Prime Sweater Ltd.

Naibari, Pubail, Gazipur.
(23.933718N, 90.450326E)

26th November 2017

Observations

Typical floor Layout

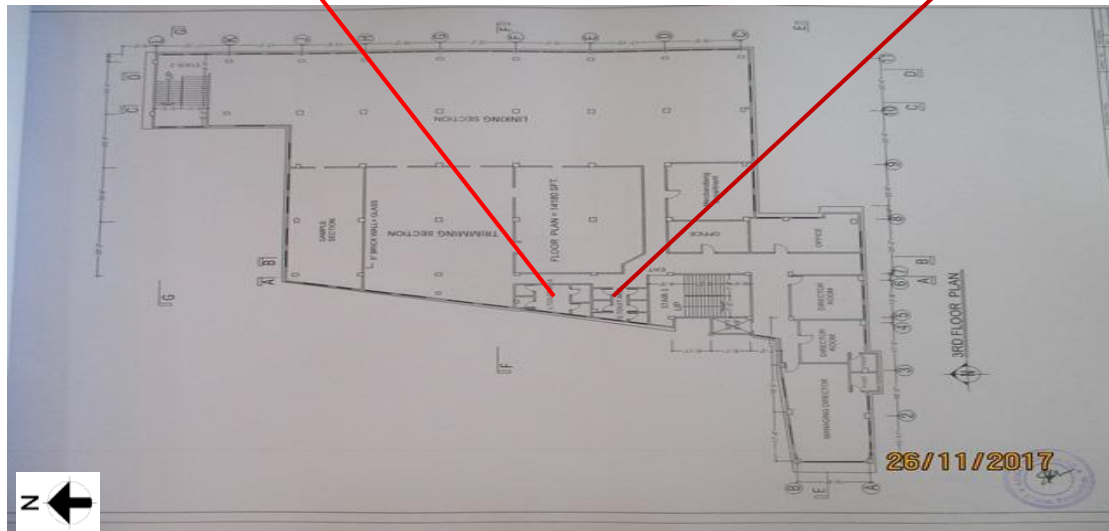
High stress level in columns that require immediate review

Cursory calculations indicate that the column stress are exceed normal design limit. A Detail engineering assessment must carried out immediately.

Column layout

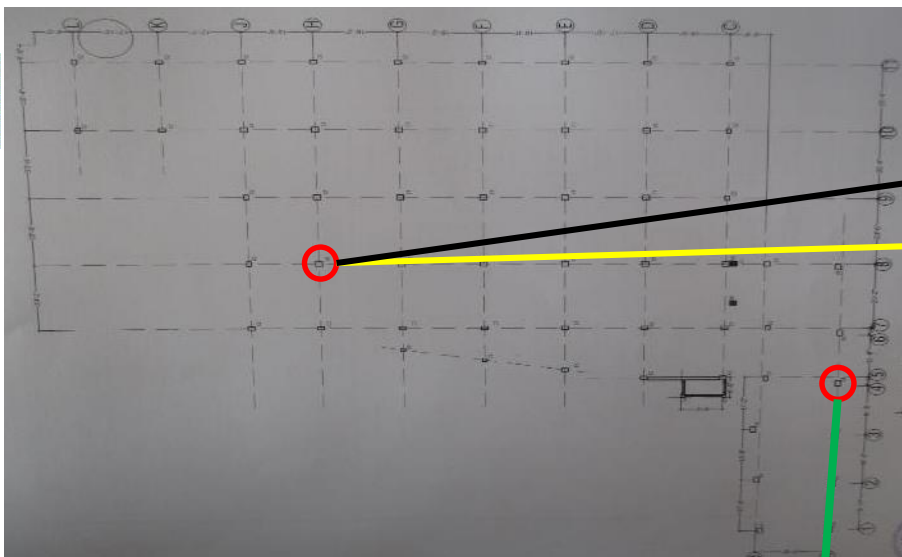
Evaluation of concrete compressive strength based on aggregate type

Stone chips
aggregate found in
basement floor
column

Brick chips
aggregate found in
1st floor column

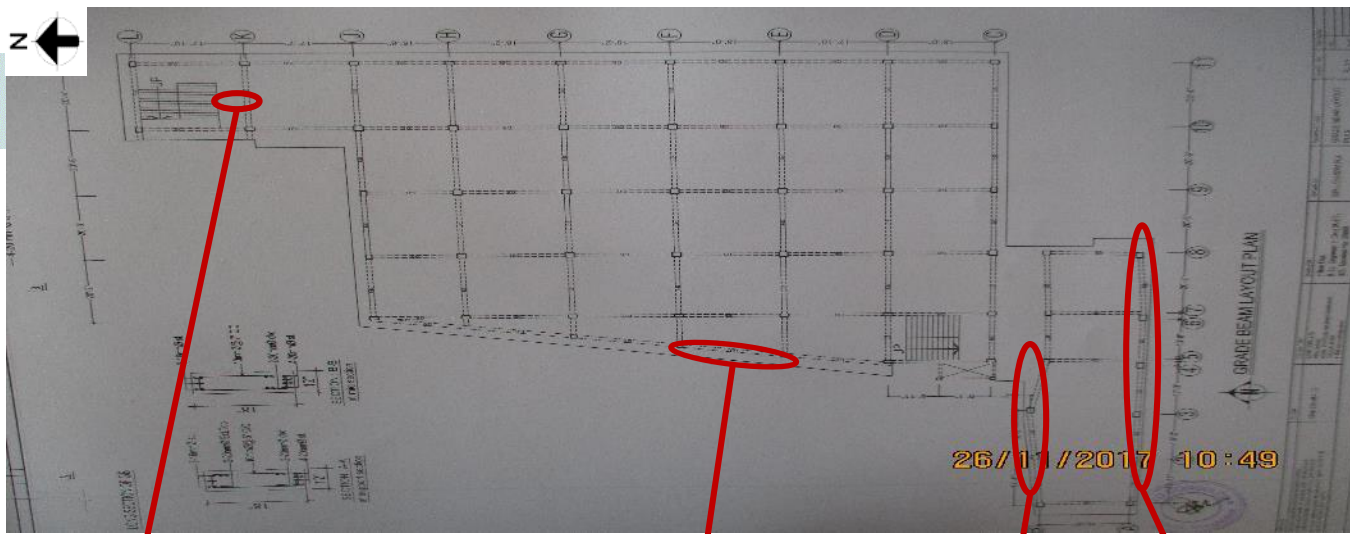
Mixed of stone
and brick
aggregate found in
ground floor
column

Stone aggregate was found in basement floor column but in 1st floor column, brick aggregate was found. Moreover, mixture of stone and brick aggregates were found in ground floor column. Whereas, stone aggregate was mentioned in all provided reports of compressive strength test. For this reason, except basement column cores test result were not considered in cursory calculation.

Provided Column Layout

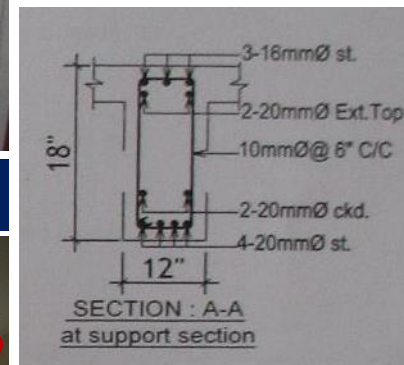
Discrepancies between provided drawing and on site condition

B-2 beam size
shown 300mm x
450mm in provided
drawing

Provided Column Layout

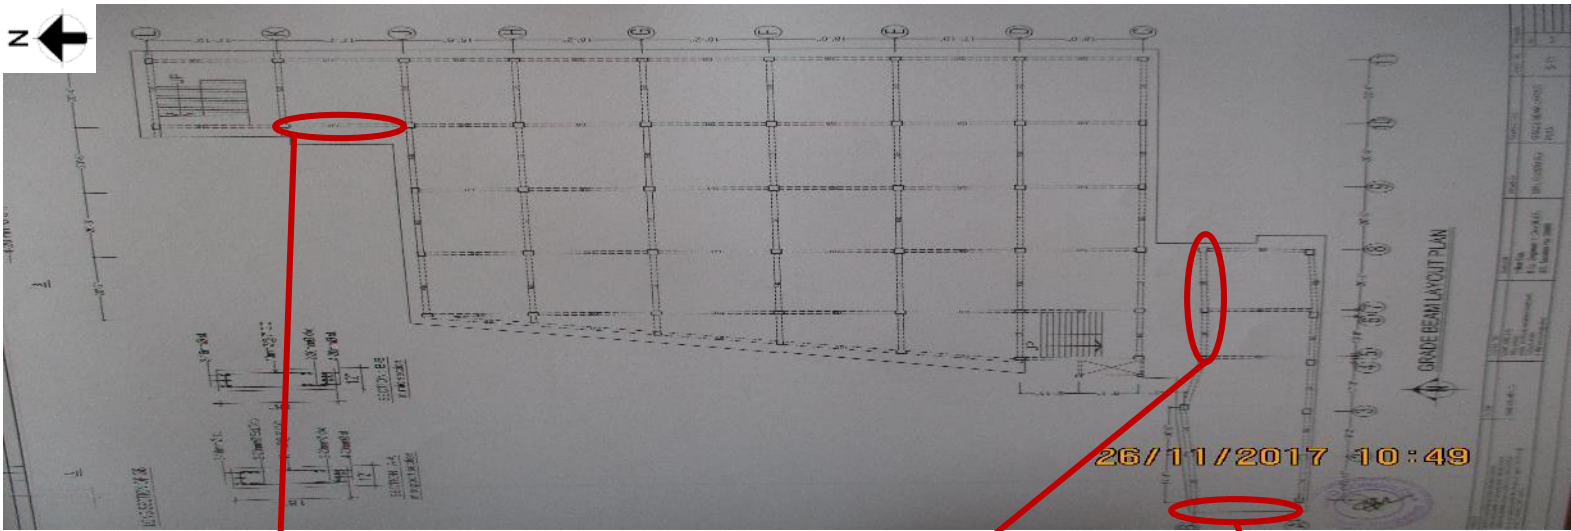
Marked beam size
measured 300mm x
375mm which was not
shown in beam layout

Marked Beam size found 300mm x 400mm at
1st floor which are denoted as B2 (300mm x
450mm) type beam in beam layout

Marked Beams were missing in 1st floor which are denoted as B2 type beam in beam layout
